# UNITED STATES PATENT AND TRADEMARK OFFICE

APPLICATION NO.	FILING DATE	FIRST NAMED INVENTOR	ATTORNEY DOCKET NO.	CONFIRMATION NO.
10/680,358	10/07/2003	Frank J. Schwab	4002-3426/PC819.00	5654

**Office Action Summary**

**DETAILED ACTION**

Figure 1

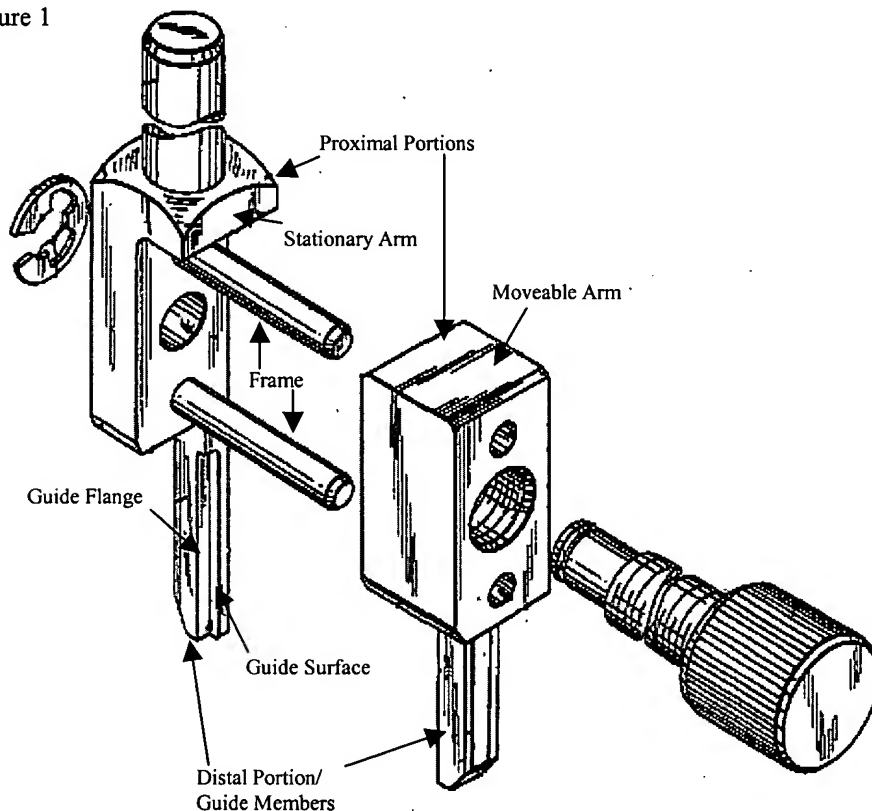
13. Claims 1, 9, 17-20, 26, and 37-40 are rejected under 35 U.S.C. 102(b) as being anticipated by Weissman (U.S. Patent 4,758,159).

Regarding claims 1, 17-20, and 37-40, Weissman discloses a device (see Figure 1 below) comprising a proximal portion and a distal portion. The proximal portion further includes a frame, a stationary arm, and a moveable arm couple to the stationary arm. The distal portion further includes first and second guide members that extend distally from the stationary and moveable arms. The guide members are moveable relative to each other by moving the moveable arm relative to the stationary arm. Each guide member includes a guide surface extending from the proximal end to the distal end of each guide member and are oriented towards each other and are generally parallel. Each guide member further includes a guide flange extending along either the first or second side of the guide member. The guide flange projecting from one of the guide surfaces towards

the guide surface of the other guide member. Regarding claims 9 and 26, Weissman discloses a device wherein the guide surfaces are planar.
